CITY OF GROSSE POINTE WOODS
PLANNING COMMISSION AGENDA
Tuesday, July 22, 2025, at 7:00 PM

Subject: 19483 Mack Avenue: My Nails Salon Site Plan for Interior Renovations
Parcel ID: 015-01-0041-000
Site Plan Review #2
Zoning: C, Commercial Business District

Subject: 20778 Mack Avenue: Site Plan
Parcel ID: 004-06-0001-001
Site Plan Review #2
Zoning: C, Commercial Business District

Rezoning Review

Sheet No. :
A010

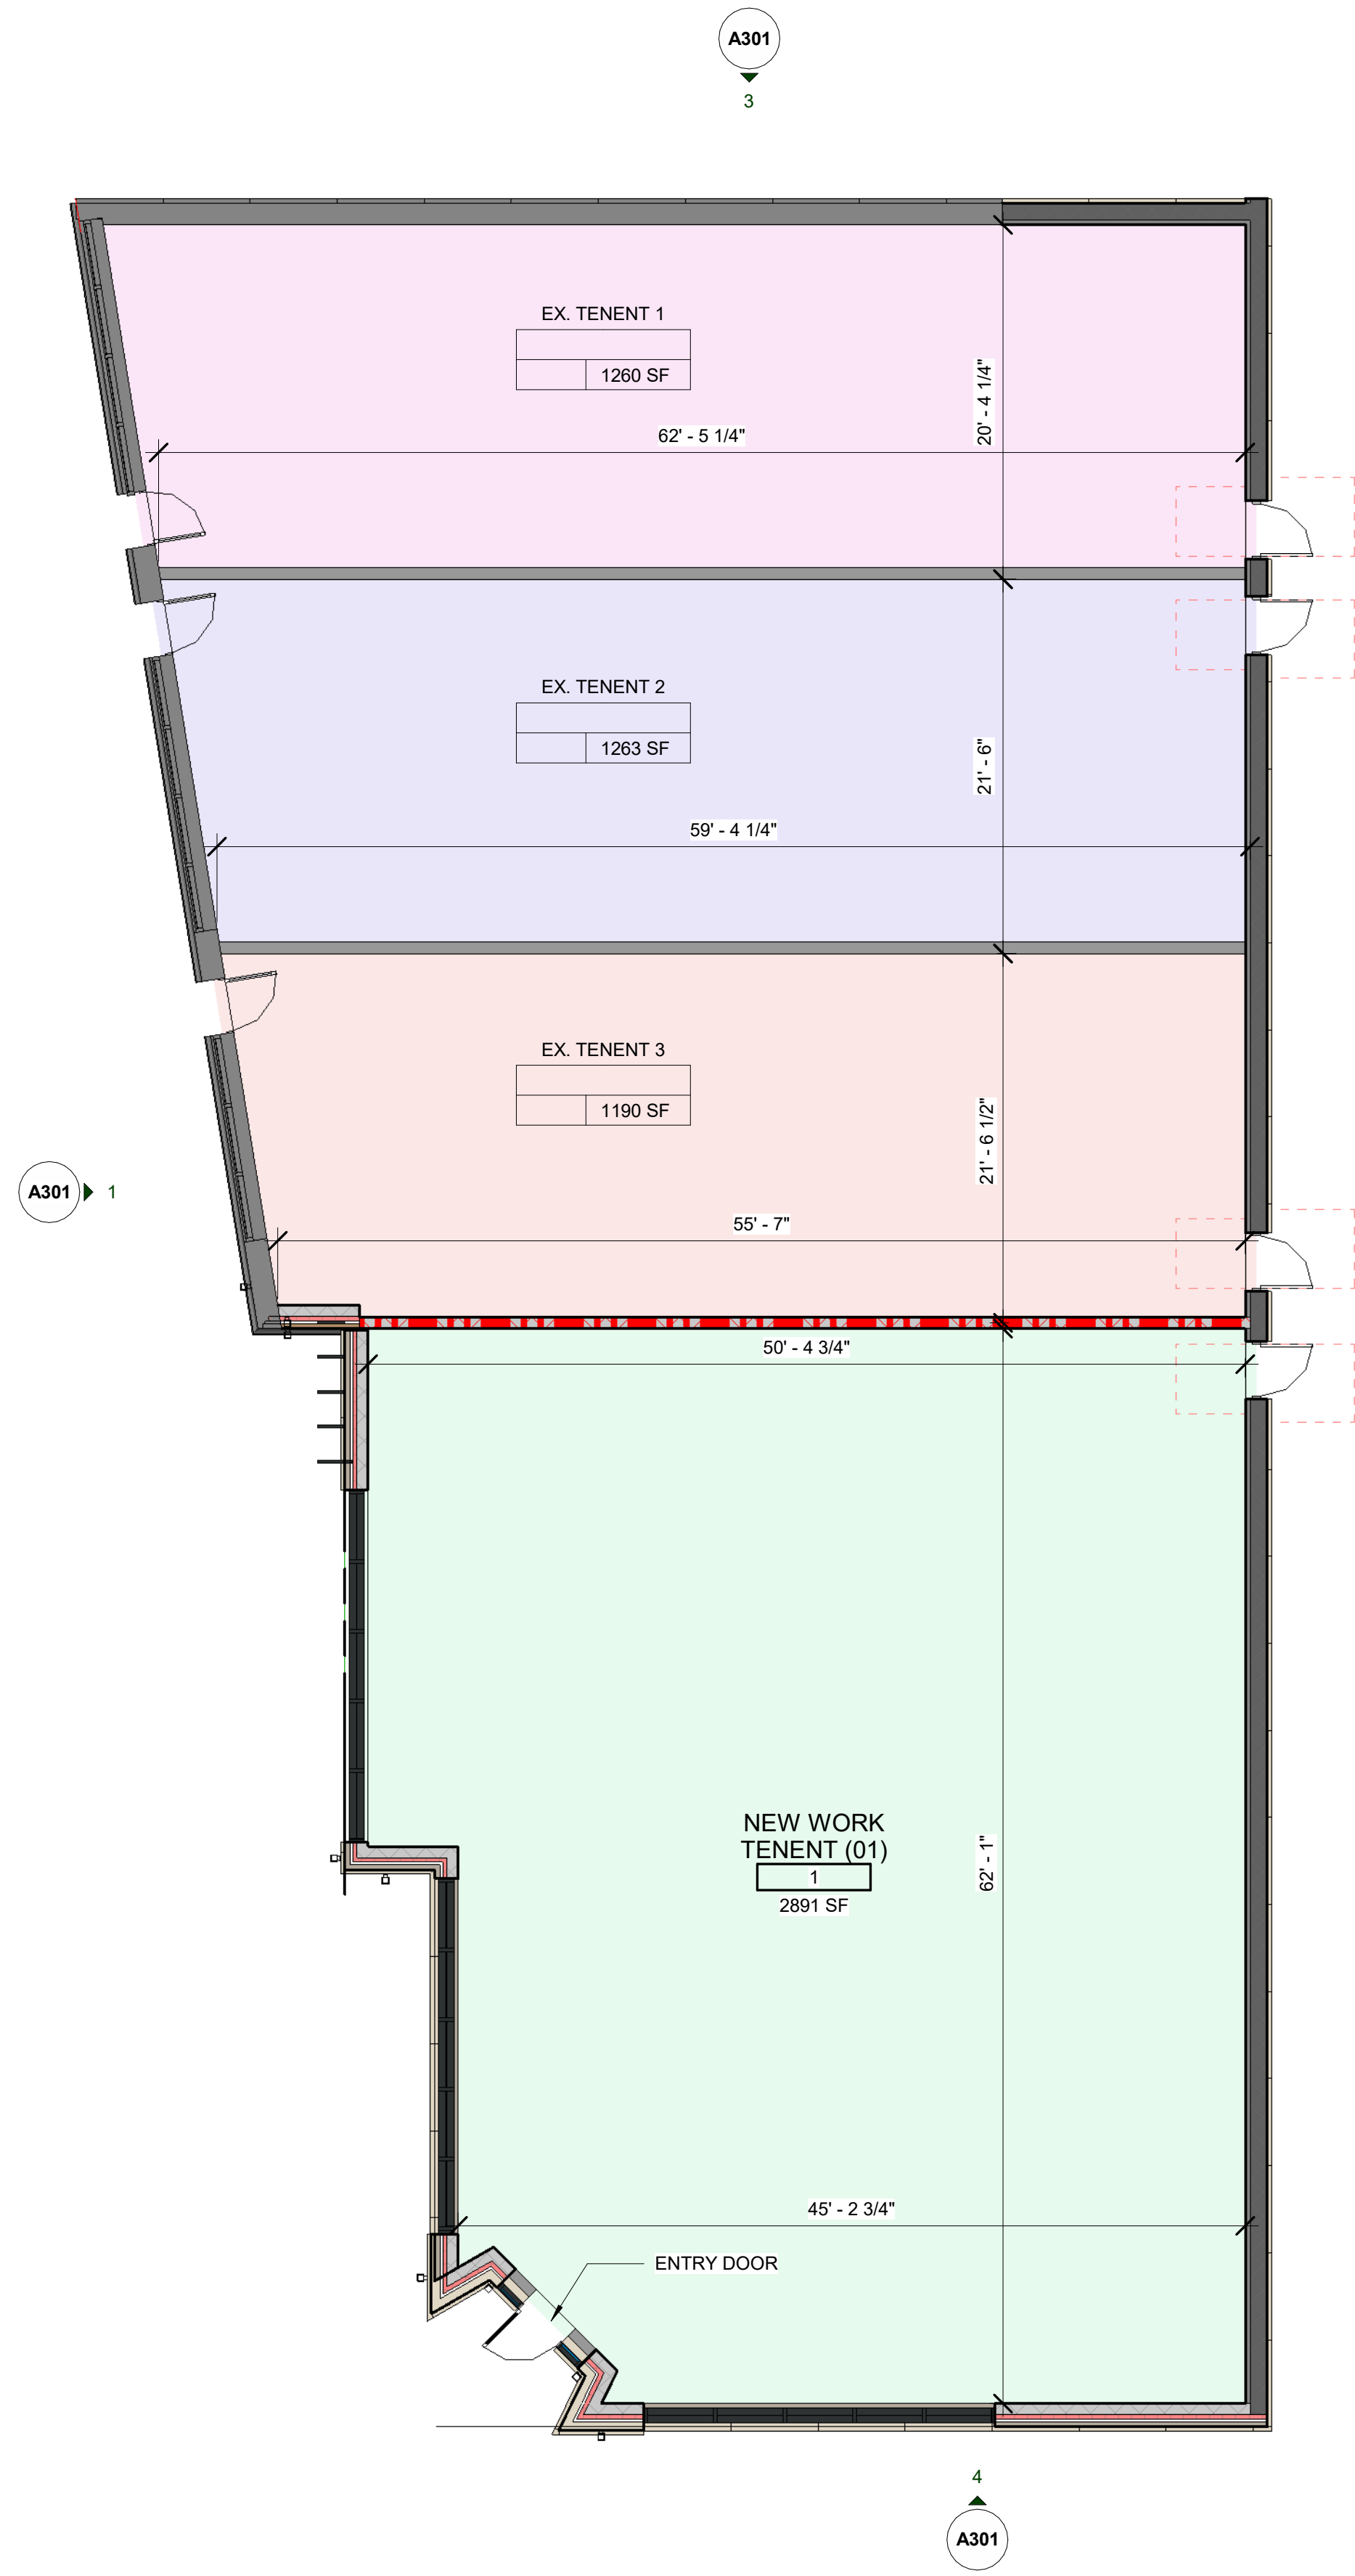
1. The height of the screen wall along the northern property line is reduced from 6 feet to 4 feet, and the type of screen wall provided (including the materials) is detailed on the site plan.
2. Per Section 50-6.1(G)(7), samples of the proposed building materials are provided to the Planning Commission at their meeting for final review and approval.
3. The proposed loading needs of the site and the restricted hours are provided. The Planning Commission shall determine if this will suffice for the loading/unloading spot requirement or if another configuration is necessary.
4. Lighting intensity and placement is reduced and adjusted on a revised photometric plan.

A 6-foot fence/masonry wall is proposed along the residential property line abutting 1875 Hawthorne Road; **the height of the proposed screening wall must be reduced to 4-feet, and the type of materials must be detailed on the site plan.**

2 Section At Dumpster Screen
A1 1/2" = 1'-0"

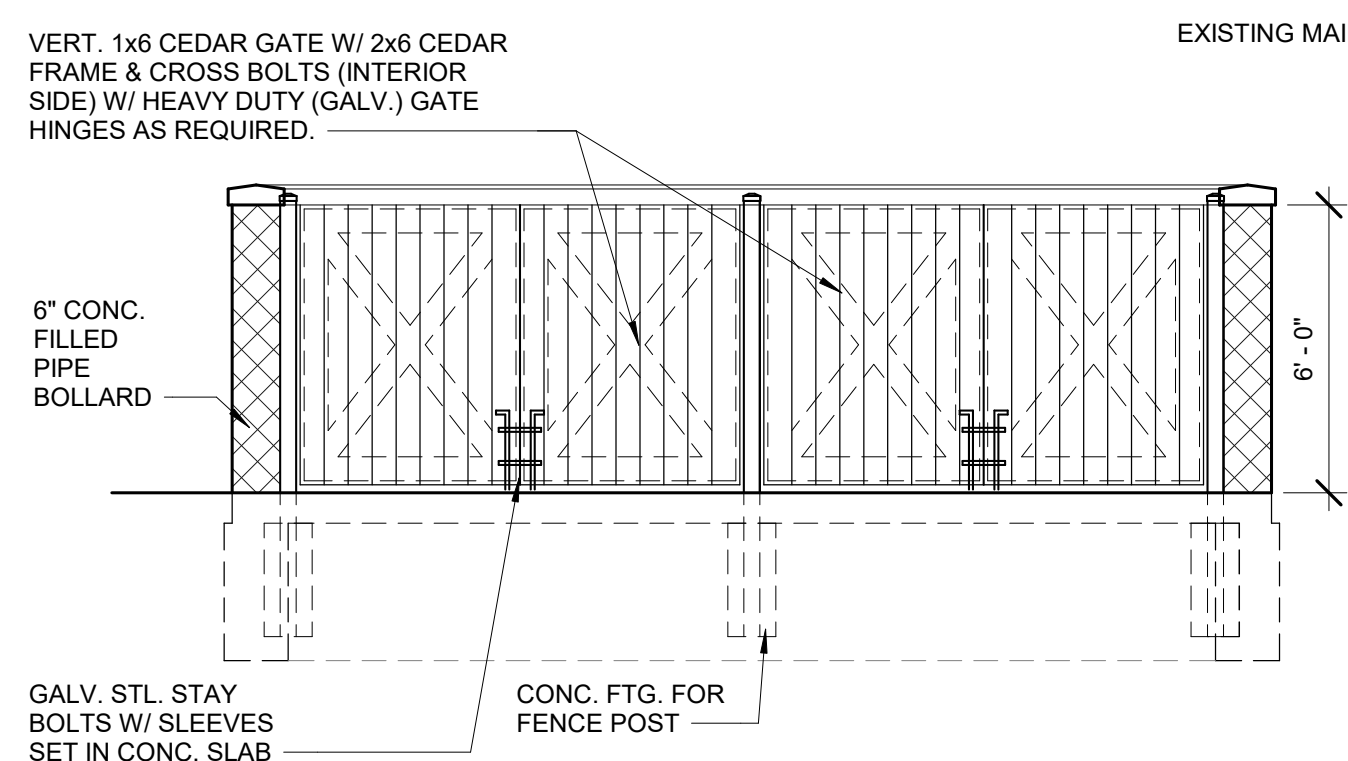
Findings: Complies. A dumpster enclosure is shown on sheet A1 with the necessary screening and building standards. Additional landscaping is proposed around the dumpster enclosure (i.e., arborvitaes) to further soften the site.
